18-011ARB-INF – FIREHOUSE PATIO

An Informal Review for non-binding feedback of a proposed 240-square-foot accessory structure, patio and associated site improvements.

4) Architecture

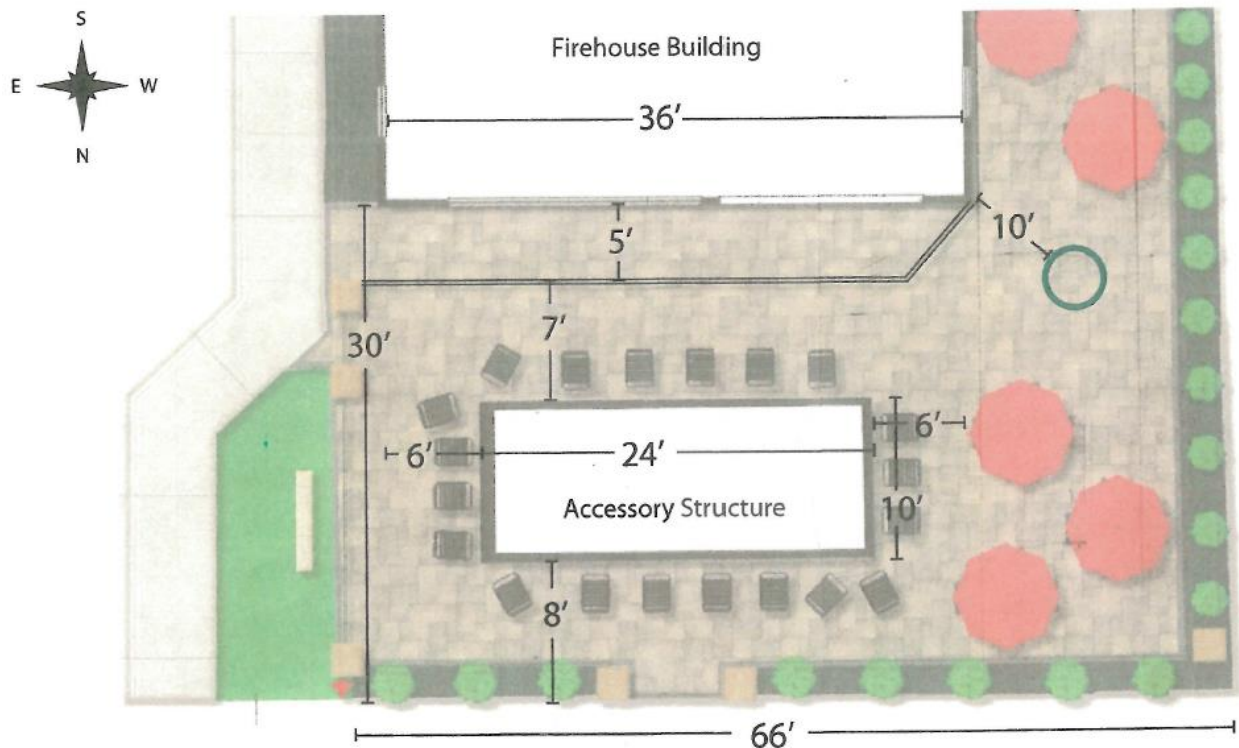
Staff: While the proposed accessory structure is smaller in height and relative scale, the overall width of the proposed bar is 24 feet in comparison to the existing structure's 36-foot width. A large portion of the existing building would be behind the proposed structure, particularly from a pedestrian perspective. The height of the accessory structure is lower than the existing building and is more compatible in scale at this proposed height; however, the height as proposed would conceal some of the central details and features associated with the firehouse.

Consultant: The consultant states that "while the accessory bar structure will provide an improved environment for walking, actively engage the space, and not destroy the historic fabric of the firehouse, the current form of the structure overpowers the historic building and is not a sensitive infill development." Further noting that the current size, scale, and location of the proposed bar hide the historic features of the

firehouse; one cannot see the original vehicle openings through the large accessory structure, nor visualize that the new patio was actually the driveway for the former firehouse." The consultant would suggest to reduce the size of the bar in length, width, and height or relocating to the side of the existing building.

Staff: The basic rectangular form of the accessory structure is consistent with the *Guidelines*, the proposed portion in width and height detracts from the character defining features of the existing building. The height of the proposed accessory structure is under two stories and is smaller in size than the existing firehouse. However, as proposed, the accessory structure does compete with the existing firehouse. While the forms are relatively comparable and the mass is smaller than the existing historic building on the site, the mass of the accessory structure covers some of the features of the existing historic building on the site.

Consultant: The consultant states that the "firehouse is approximately 36' wide and 23' tall while the proposed bar will be 24' wide and 12.5' tall; this leaves little room to actually see the historic structure behind the bar. Most of the stone façade, as well as the character-defining vehicle openings and commemorative plaques, will be hidden behind the new structure." The consultant recommends reducing the mass and height of the accessory structure and consider relocating to one side.

Staff: The proposed accessory structure would be located in front of the existing building on site. The accessory structure is shown as a 24-foot by 10-foot, free-standing building at a height of 10 feet. Typically, accessory structures are located to the rear or side of the principal building. The existing firehouse building is 7,100 square feet in size and is 22.5 feet in height. While smaller in size than the existing building, the full width of the proposed accessory structure in the proposed location would obscure a majority of the street facing façade of the existing building.

Staff: The open concept with the bi-fold style garage doors help reduce the visual mass of the accessory structure and the use of stone is compatible with the *Guidelines* and established character on site. The wrought iron fencing proposed around the perimeter is similar and in character with other fencing in the Historic District. The red color on the roof and window system is not consistent with the *Guidelines* in terms of color, which state the colors of unpainted brick or stone walls are the base colors, and trim colors should be selected to be compatible. Additionally, considering the use of light and dark shades of the same color when choosing body and trim colors is recommended.

Consultant: The standards for rehabilitation from the Secretary of the Interior state "*new additions, exterior alterations, or related new construction will not destroy historic materials, features, and spatial relationships that characterize the property. The new work shall be differentiated from the old and will be compatible with the historic materials, features, size, scale, and proportion, and massing to protect the integrity of the property and its environment.*" As an accessory structure, the bar addition will leave historic materials and features intact. And the new structure will be differentiated from the old by the use of new materials such as metal, glass, and concrete. The overall design of the accessory bar, with its independent structure, use of new materials and features, is compatible with the historic building. However, the consultant does note that "the Ohio Tan Block masonry of the bar structure should be compatible with, but not identical to, the stone exterior of the firehouse.

And, it should resemble real stone, not a fake substitute.” The consultant notes that stone material usually does not appear in a gable front unless there are stone walls or several stone columns to support it and therefore recommends that a different material—but one compatible with the historic character of the district—should be used in the gable.
